ORDINANCE NO. 2009-039

AN ORDINANCE GRANTING CERTAIN APPROVALS FOR PROPERTY
COMMONLY KNOWN AS THE OAKS OF VERNON HILLS PUD LOCATED ON
THE NORTH SIDE OF ROUTE 45 BETWEEN CORPORATE WOODS AND
WOODLANDS PARKWAYS, IN THE VILLAGE OF VERNON HILLS, LAKE
COUNTY.

Re: *Oaks of Vernon Hills Landscape Plan – Tree Preservation Plan
Technical Review #4*

Tree Preservation Plan Comments

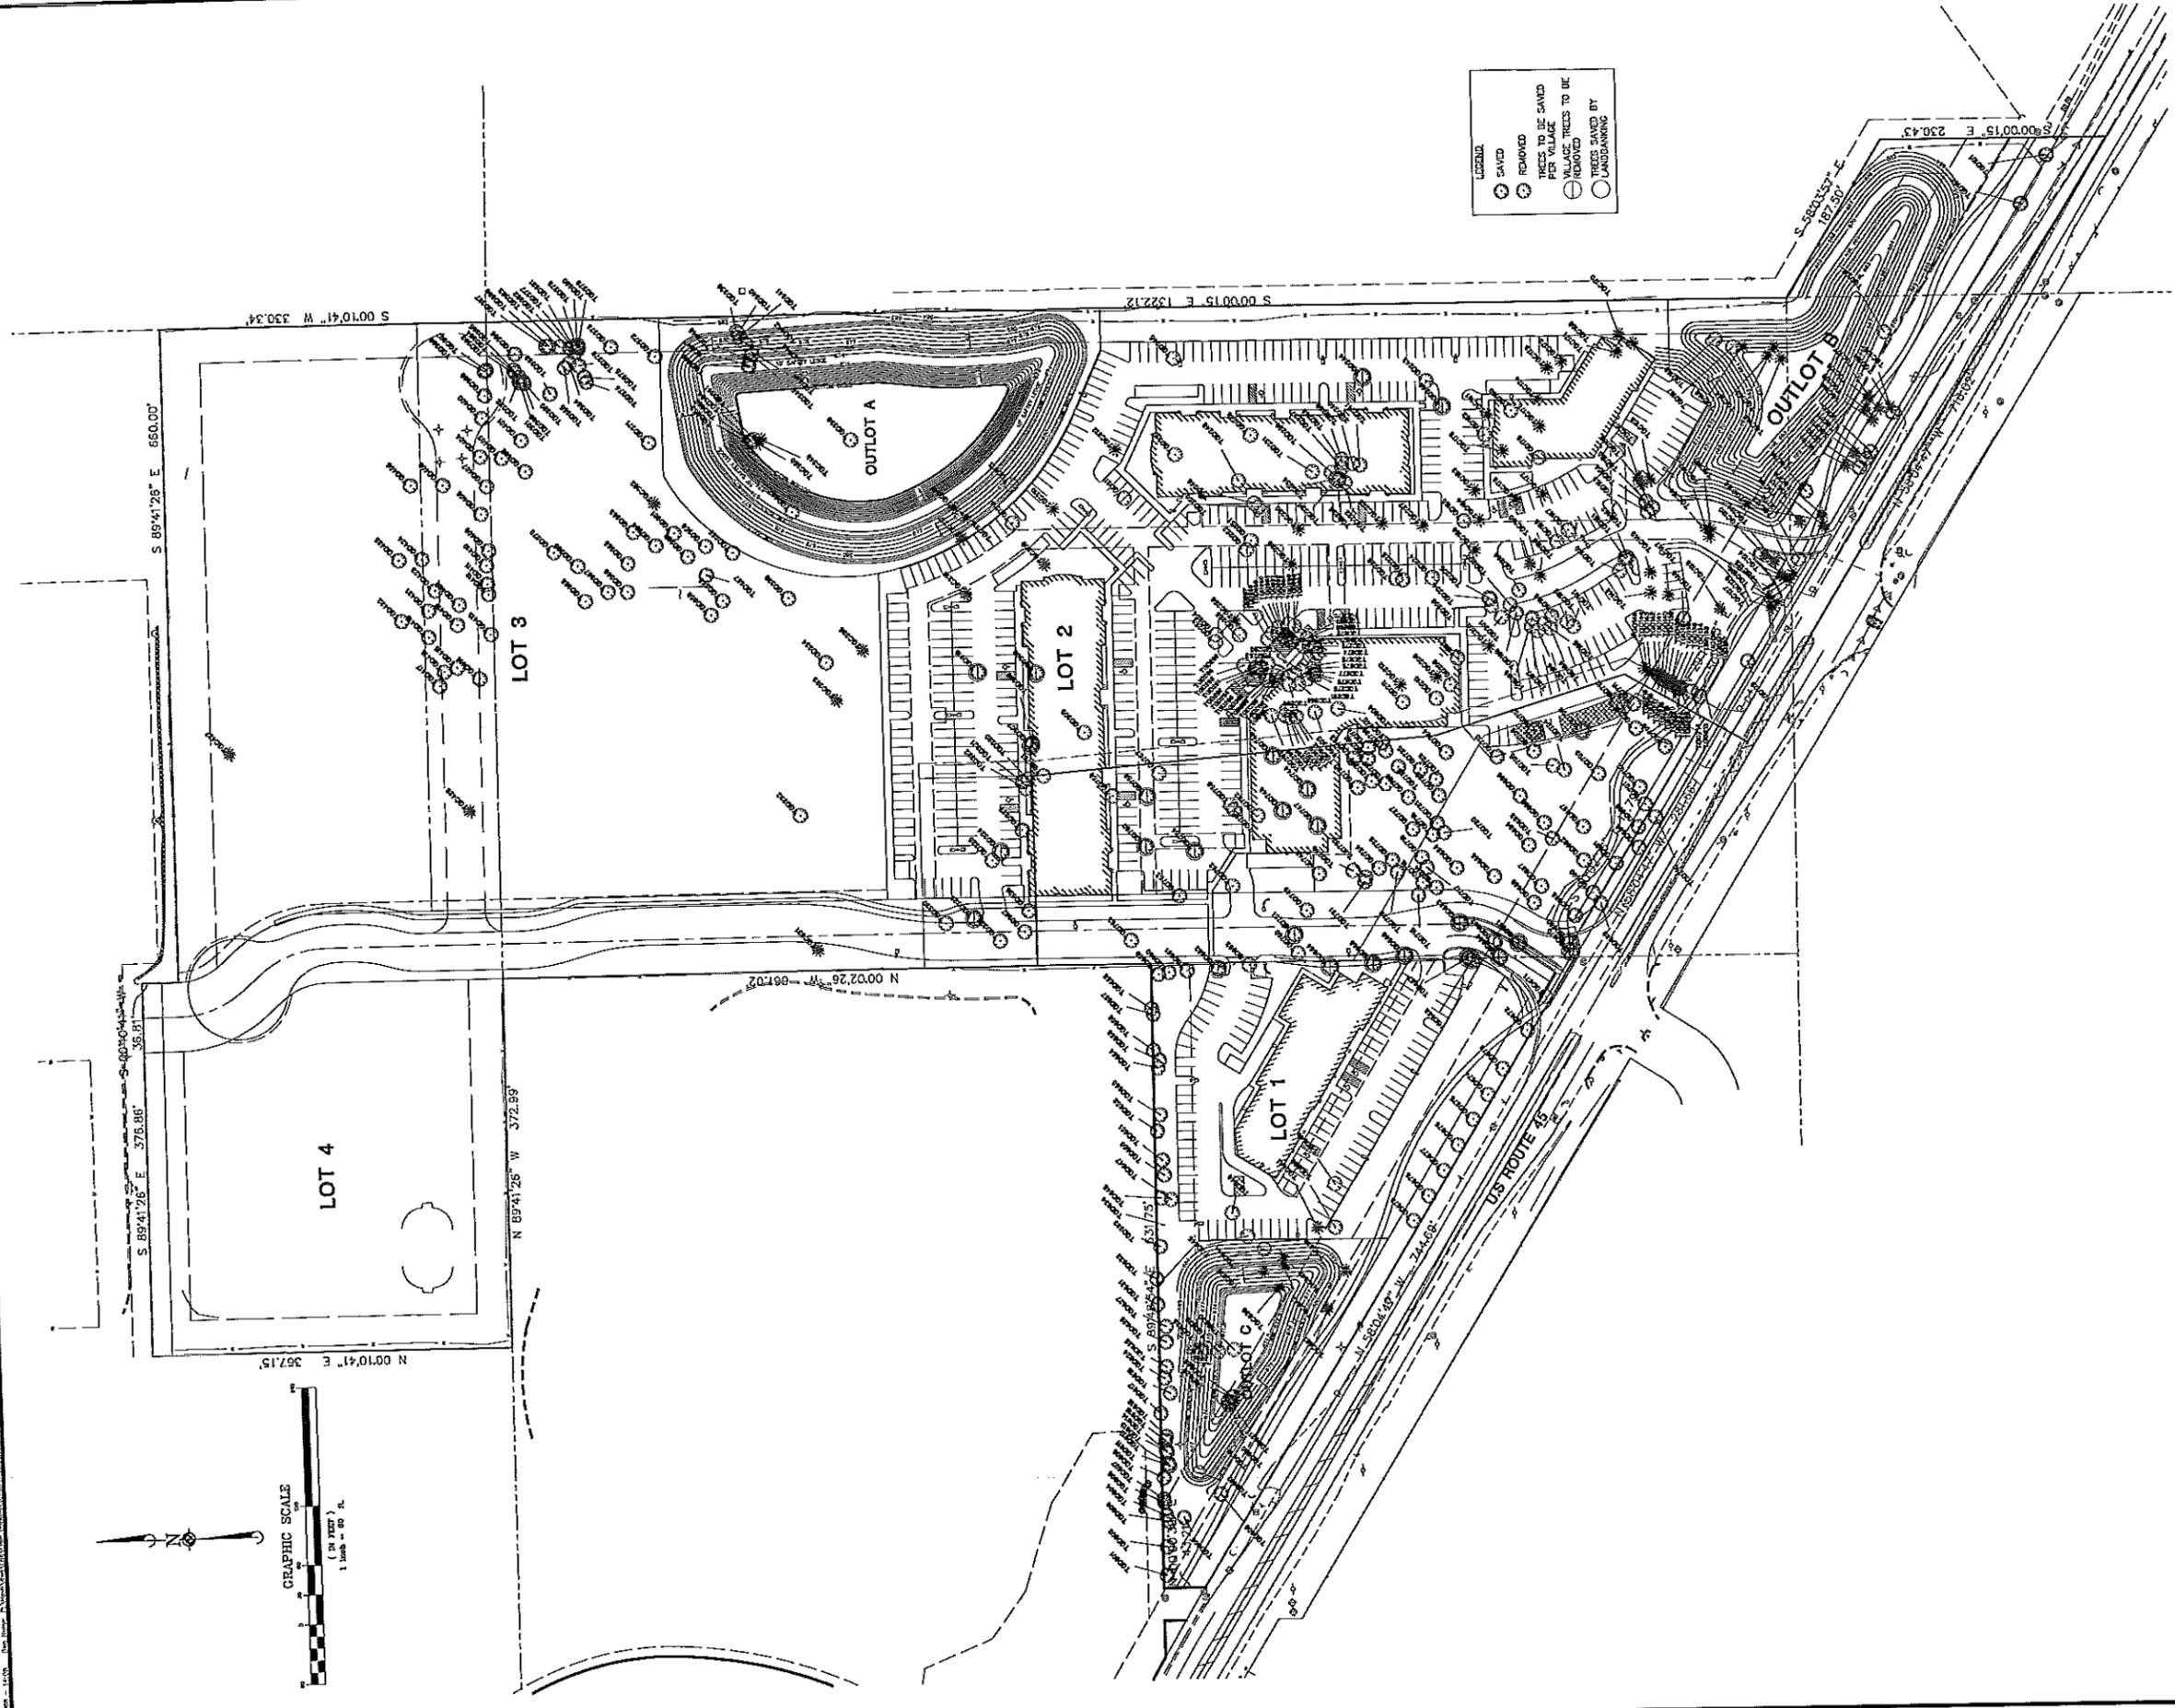
1. Section 2.02. Tree Inventory – We request the petitioner review this section and provide the missing information for elevation and crown spread for all trees in the Tree Inventory report. The elevation and crown spread of the tree are needed to verify how the proposed improvements will work with the existing trees to be saved. Prior to final engineering submittal, analysis of trees impacted by grading operations will be reviewed in the field where observation of tree canopy sizes and elevations will allow us to make a final judgement of the preservation / removal of the tree, or grading revision to save the tree.

3. We request that the petitioner revise the grading plan around tree #115, a 29" Scarlet Oak with a 2 rating, so that no part of the grade be revised within the drip line of the tree. Adjustment will be made at final engineering. See comment 1.

8. We request that trees numbered 672-679 be removed, they are poor quality, ½ dead; lightning struck and have no value. See landscape plan comments for replacements for that area. Trees will be removed and replaced as per comments.

L-3

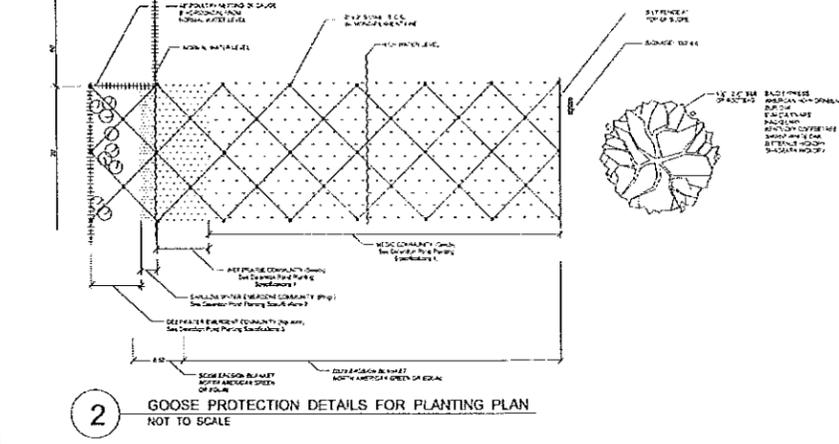
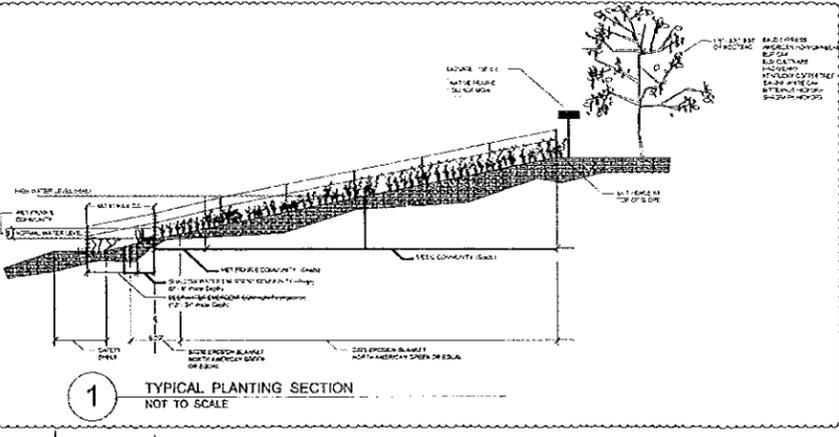
1. Remove Wetland Mix and Wetland Prairie Mix from the plans, Village Exhibit #47 will cover seed mixes to be used within the pond areas. The two mixes will be removed.
2. Include typical planting details for Trees, Shrubs and Perennial beds. Details will be included.
